AGENDA
PLANNING COMMISSION PUBLIC HEARING/REGULAR MEETING
CITY OF FARMINGTON HILLS
DECEMBER 18, 2025 @ 7:30 P.M.
FARMINGTON HILLS CITY HALL – CITY COUNCIL CHAMBER
31555 W. ELEVEN MILE ROAD, FARMINGTON HILLS, MICHIGAN 48336
Cable TV: Spectrum – Channel 203; AT&T – Channel 99
YouTube Channel: <https://www.youtube.com/user/FHChannel8>
www.fhgov.com (248) 871-2540

Special Land Use Review

Case: SA 66-10-2025
Site: 36336 W 8 Mile Road (22-23-32-326-057)
Applicant: Brown and Caldwell
Plan Date: 9/20/2025
Zoning: RA-1 One Family residential (20,000 sq ft)

Case: SA 67-10-2025
Site: 27900 Orchard Lake Road (22-23-11-35-10-13)
Applicant: Brewtopia Michigan, LLC
Plan Date: 10/10/2025
Zoning: B-3 General Business

SITE PLAN

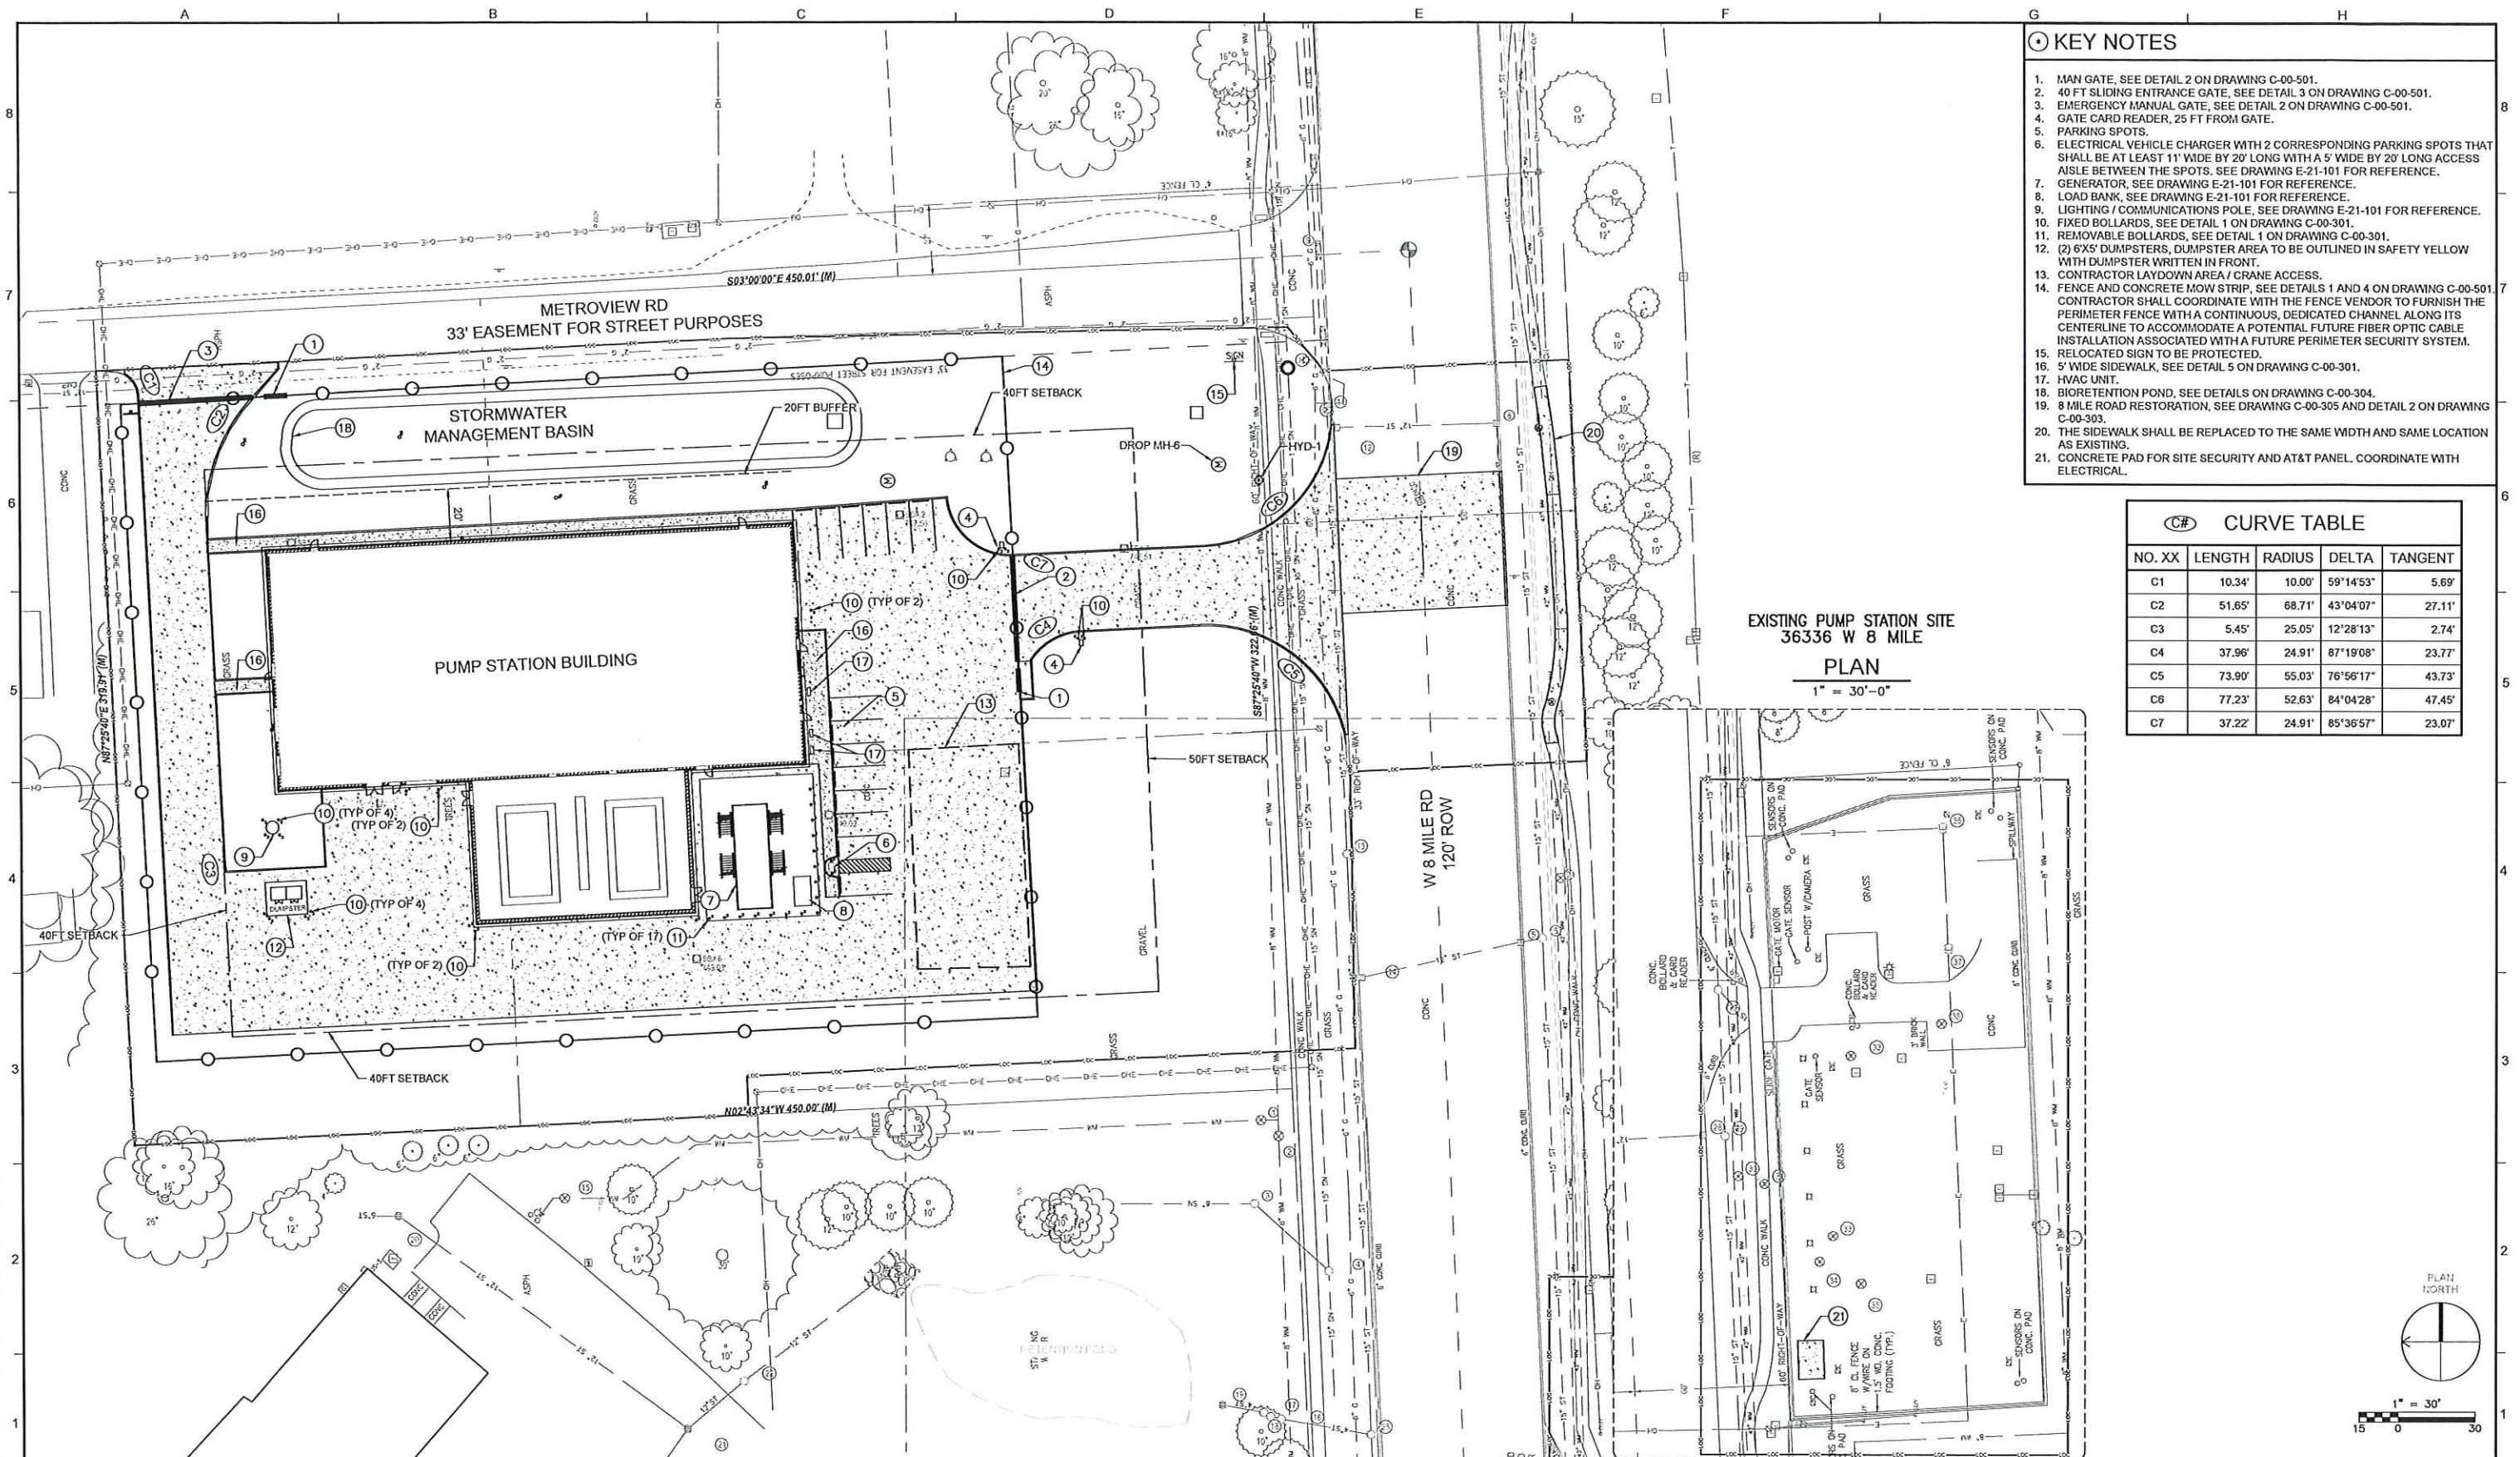
5. **Mechanical Equipment (34-5.1.4.D).** Ground-mounted equipment is contained within walls.
6. **Minimum parking (34-5.2).** Section 34-5.1 does not include a parking requirement for this use. The facility will not have permanent on-site staff. 14 spaces are provided on the plans. A barrier-free space is provided. **As this is not a permanently staffed facility, the Planning Commission should discuss with the applicant how many spaces are actually necessary.**
7. **Off-street parking dimensions (34-5.3.3.A & B.).** **Parking spaces are not dimensioned on the plans.**

10. **Circulation.** The applicant proposes primary access from 8 Mile Road, and also provides a driveway onto Metroview.
11. **Landscape Development (34-5.14).** **The applicant has provided a plan that identifies the location of existing trees, but an inventory has not been provided, nor has a tree replacement plan. It appears that all trees on the site will be removed.**

2. The topographic plan does not identify an easement on the 8" public water main running along the south side of the site. If it does not exist, a new one must be provided.

3. The plan currently identifies two drive approaches with one on Eight Mile Road and one on Metroview Road. Both appear to be in the neighborhood of 45' wide at the right-of-way/easement line. Section 26-52 of the City Code requires approaches to be no more than 30' in width from back of curb to back of curb at the right-of-way or easement line.

LANDSCAPE PLAN

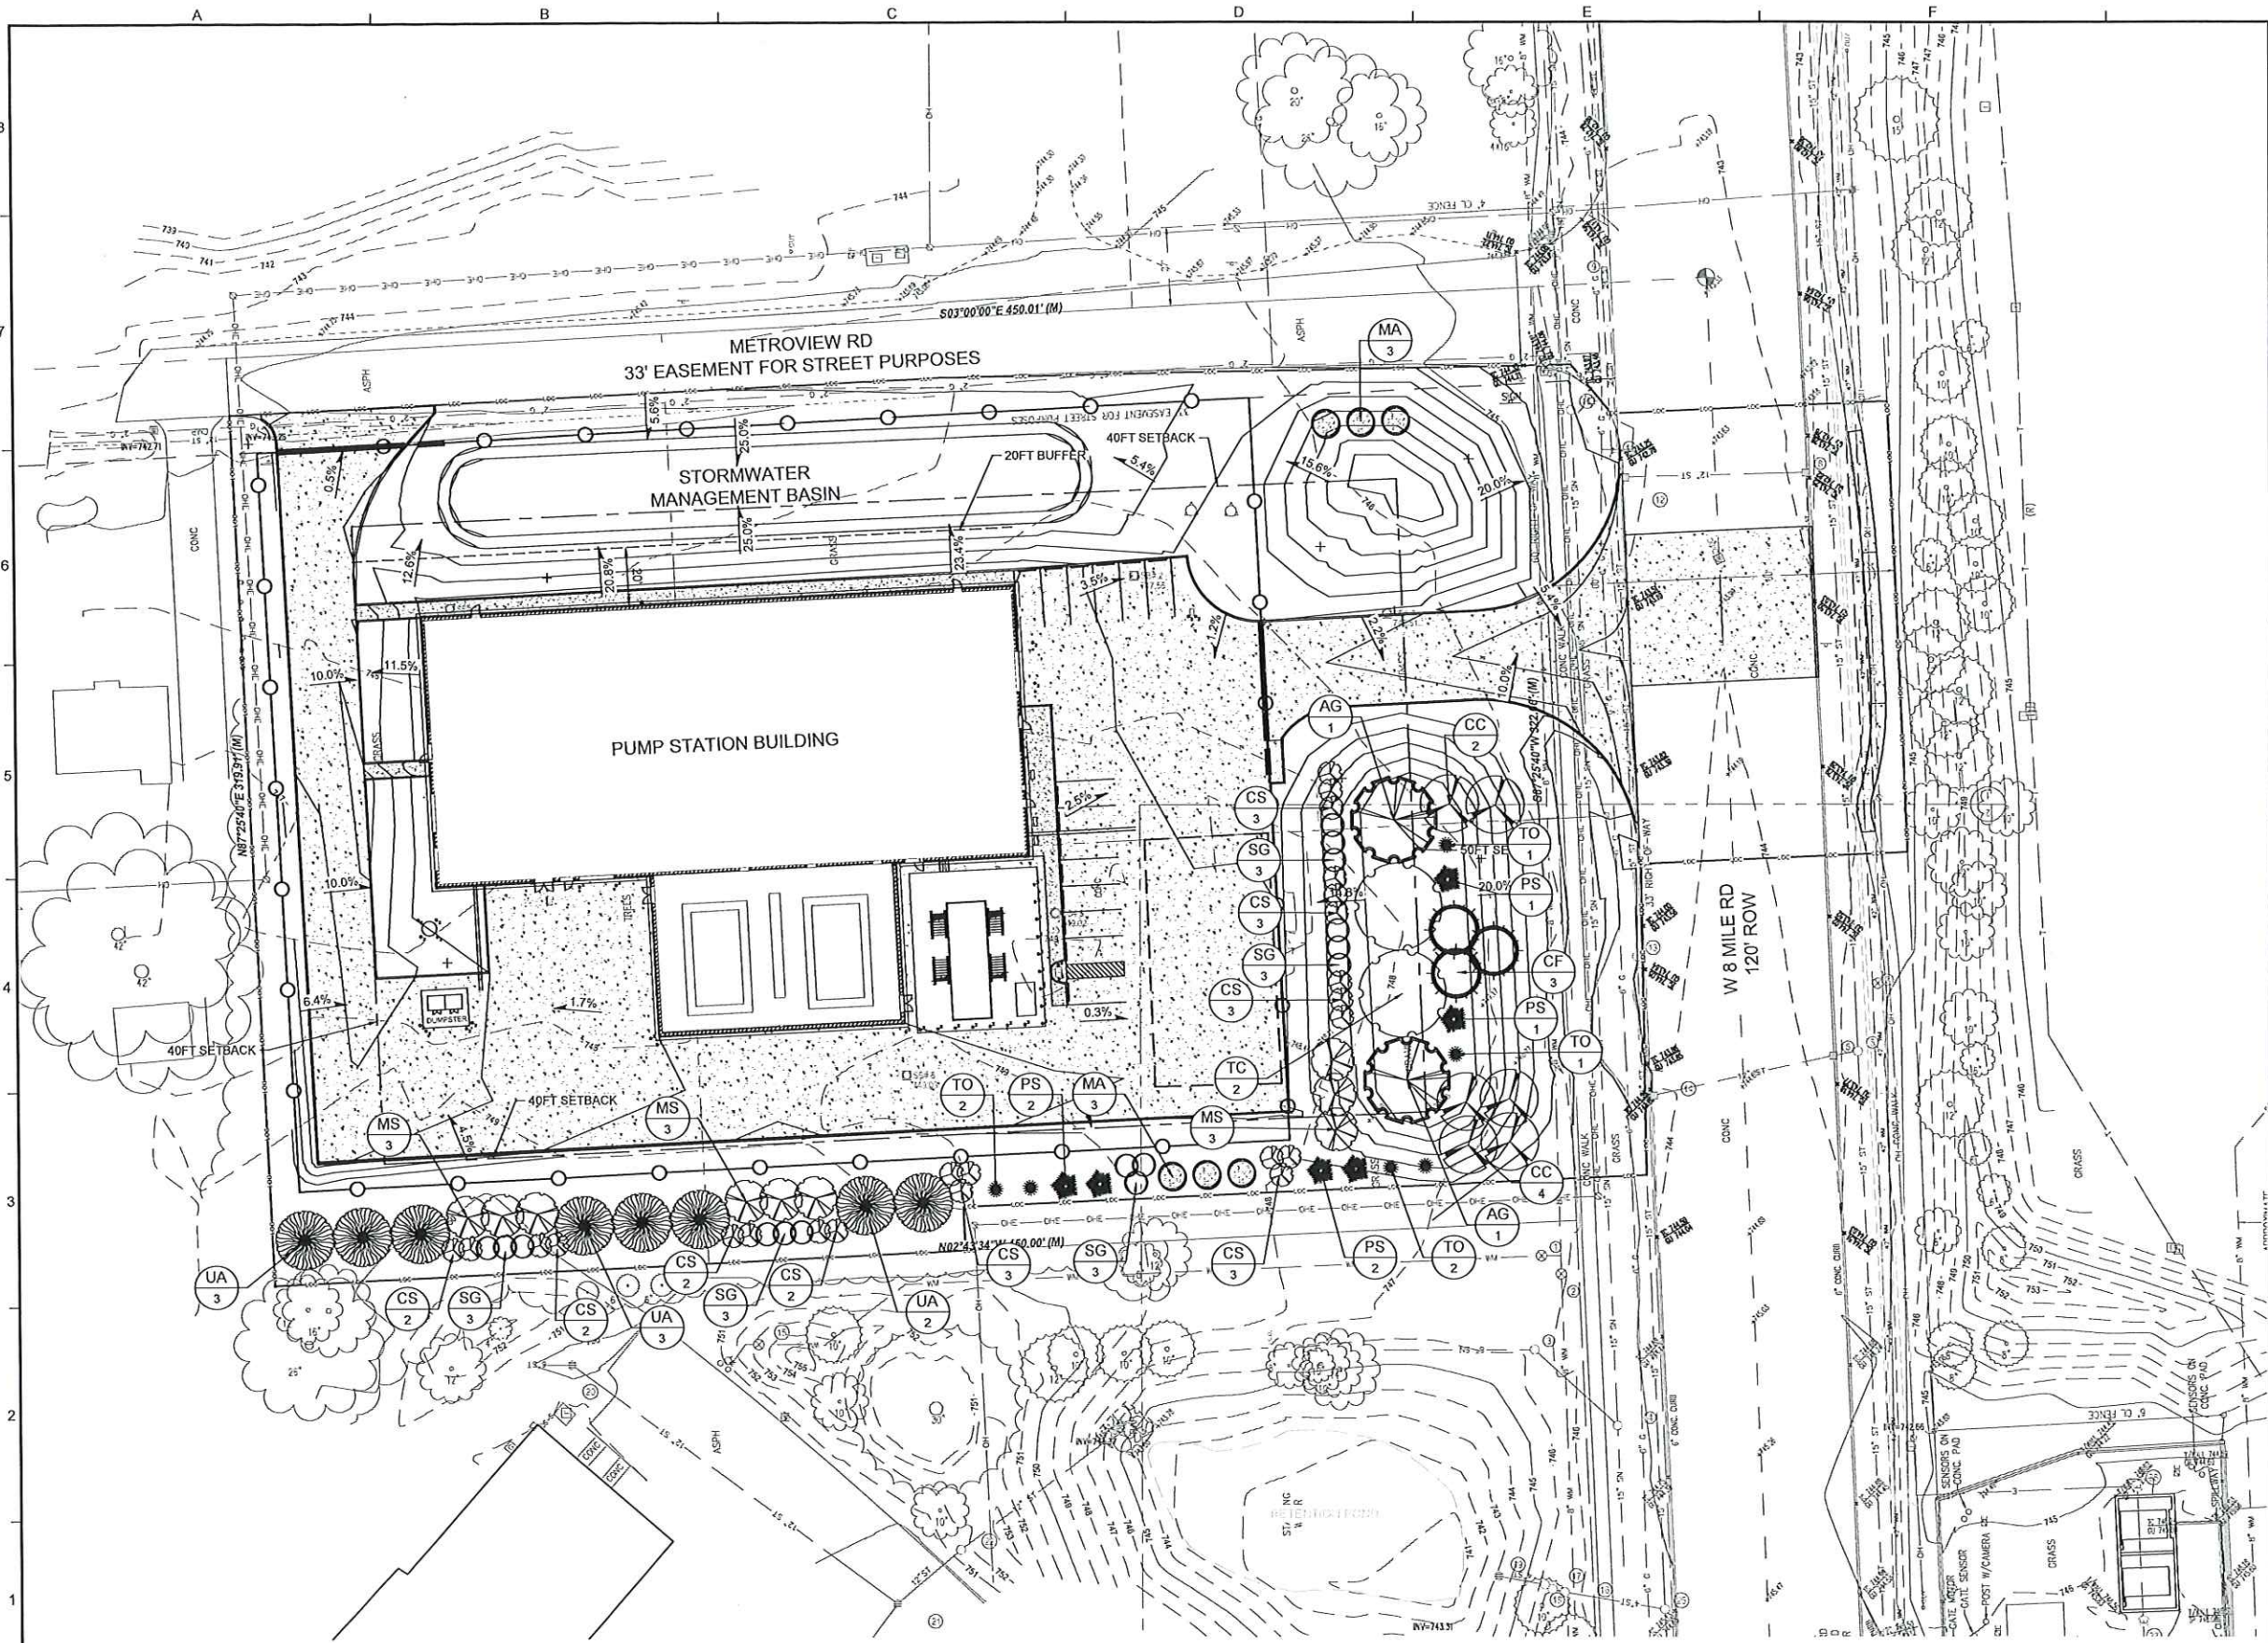
Item	Required			Proposed/Comments
• Evergreen Trees	8 ft. height	20 ft.	12 ft.	N/A
• Narrow Evergreen Trees	5 ft. height	10 ft.	5 ft.	Standard is met
• Large Shrubs	30 in. height	10 ft.	5 ft.	<i>Plans state 24"-36". 30" min required.</i>

• Hedge shrubs	24 in. height	3 ft.	3 ft.	Standard is met
Distance between plant materials	Spacing shall be provided in accordance with 34-5.14.3.g			Standard is met
Canopy Trees	Shall be large deciduous and distributed evenly throughout the paved area			Only three trees were provided around the perimeter of the lot.
Minimum number of parking lot trees (34-5.14.4.C)	1 per every 2,800 square feet of paved surface area 21,564 sf of paved area/ 2,800= 8 trees required			A tree requirement for the parking lot was not provided.
Parking lot screening from public thoroughfare (34-5.14.5)	A planted hedge of small shrubs, or A masonry wall or berm of 2 feet high			Provided. <i>There are two berms and significant landscaping meeting the standards of Section 34-5.15.6.A. in the front and west side yards.</i>
Wall or Berm (34-5.15)	Required when abutting a residential district. (See 34-5.15)			Site is in the RA-1 district, but does abut other RA-1 sites. Extensive landscaping is proposed on the west property line. However, no screening landscaping is proposed along the north property line, which is where the property abuts a residential property. A wall would typically be required in this location, but the PC may approval a greenbelt in lieu of a wall. The eastern yard is not landscaped; there is a detention basin in that yard.

Tree replacement (34-5.18)	All trees proposed for removal shall be replaced in accordance with this section			Tree removal plan needed.
